Release Notes for the SAF85xx RFE SW

Rev. 0.8.19 — 29 September 2023

Release Notes

Figure 3 Chirp Active Signal

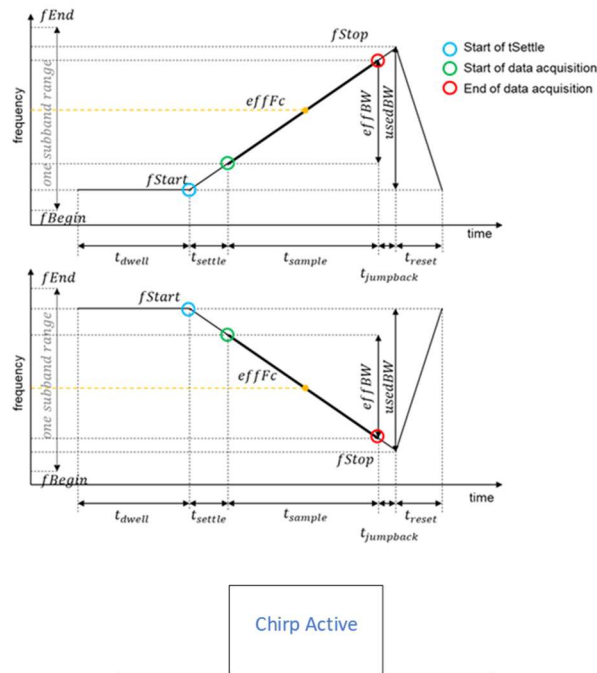
- * Added new parameter in the General Section for Chirp Active signal that configures IO pins (rfe io 3 and rfe io 5) as indicated in Figure 3. This is an optional parameter and default is zero (none). If not used then this can be skipped in the XML

Figure 4: Figure indicating change in calibration centre frequency

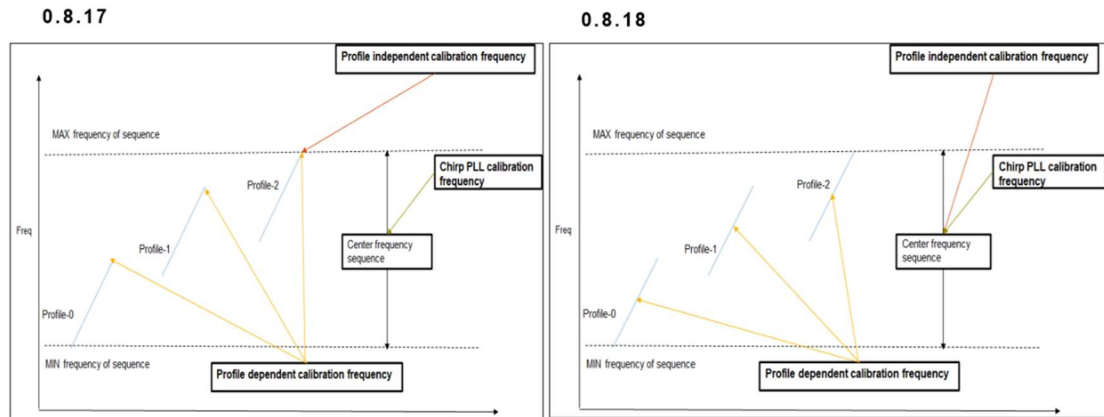
Profile independent calibration is performed at the center frequency of all the profiles (previously done at the max frequency of radar cycle)

Profile dependent PA calibration is performed at the center frequency of profile (previously done at the max frequency) as shown in Figure 4

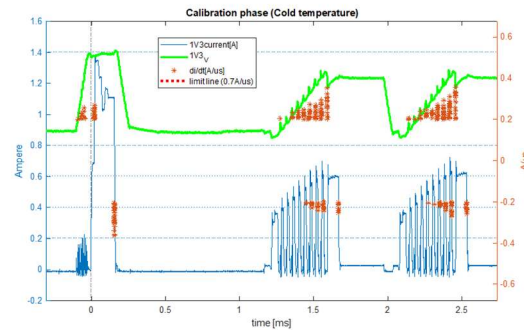
* ChirpPLL VCO (AAFC) Calibration longer lock time, causing RF stop at cold, is solved.

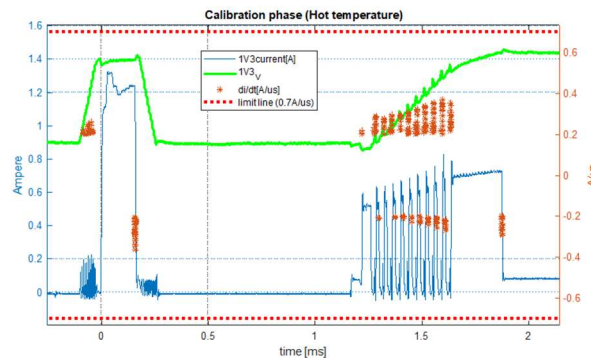
* di/dt at cold temperature during 'configuration calibration'.
